A G E N D A

Architectural Review Board

March 22, 2022 – 5:30 p.m.

Trinity Church Sanctuary Building Sanctuary Window Details ~ Obscure Glass

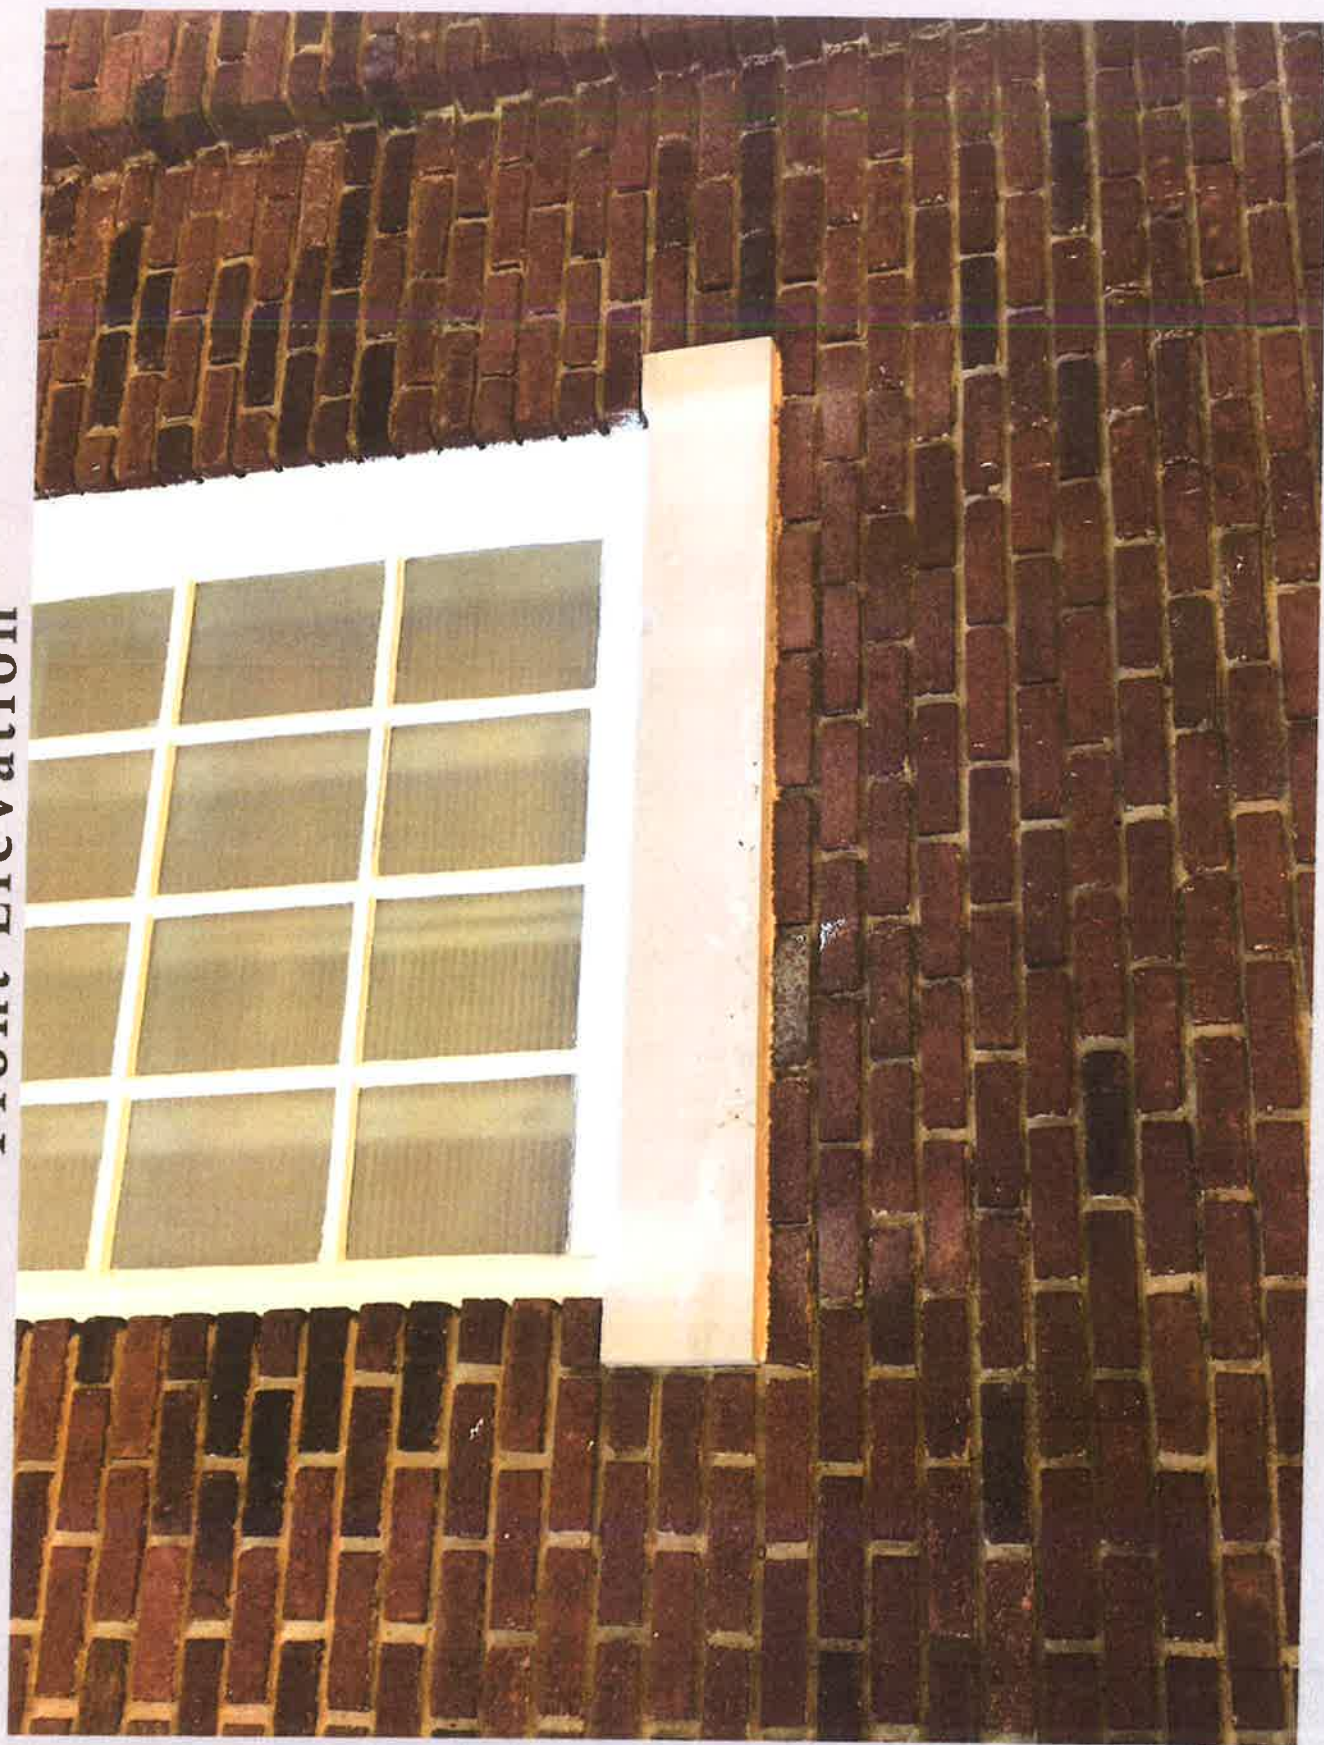
- I have seen the Sierra Pacific windows in Southern Sash’s showroom and remember thinking “that’s a good looking window”, but it is not one that has been brought before the board to date.

Trinity Church Hull St. Connector

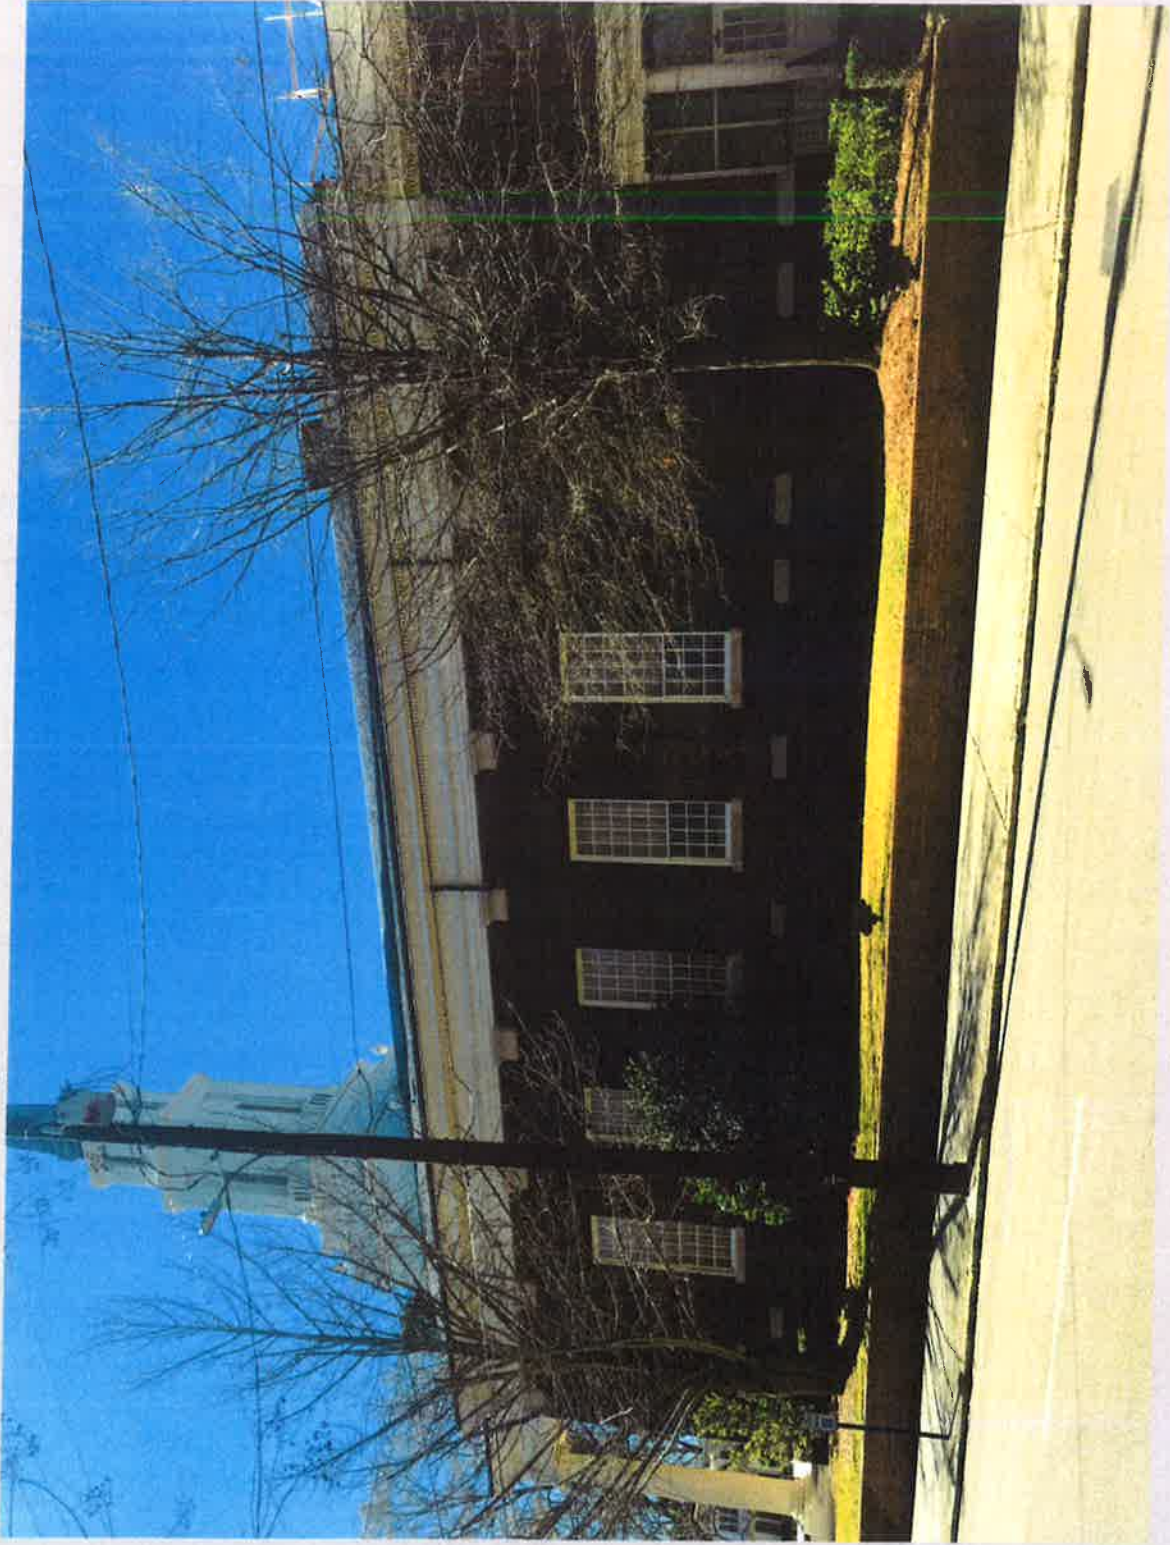
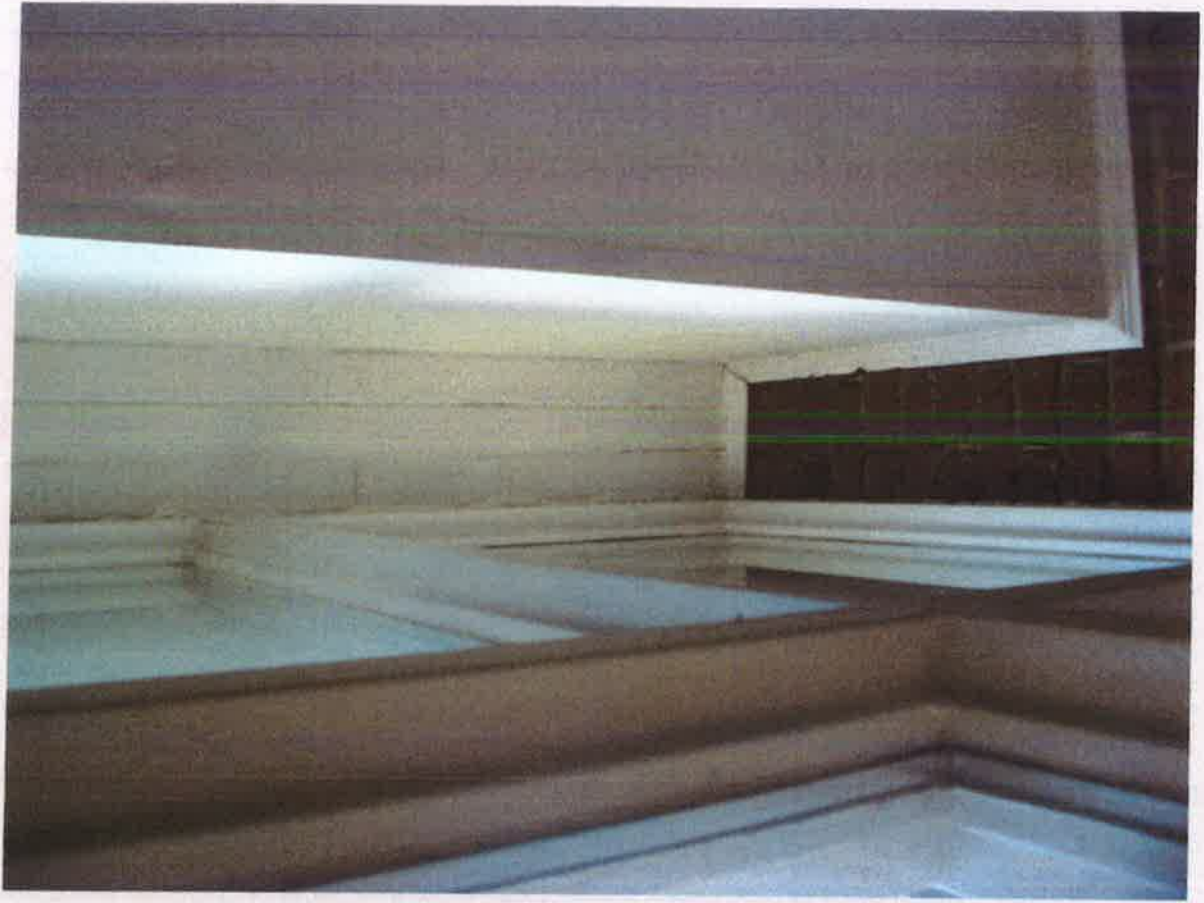
- No objection.

1103 Magnolia Curve

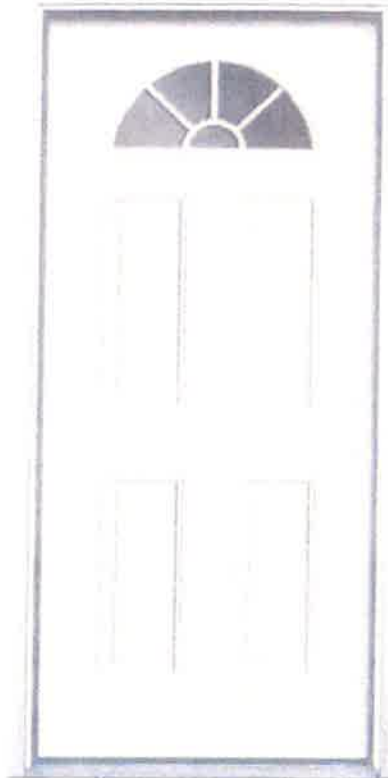
- The Board has generally required front door replacements in wood.
- The apartment building takes its stylistic cues from Colonial Revival architecture. The solid 6-panel front door is an appropriate door for this building. The owner would like to introduce some light into the entry, a paneled door with rectangular lites may be a better choice over the demi-lune. Tucker wood door is illustrated.
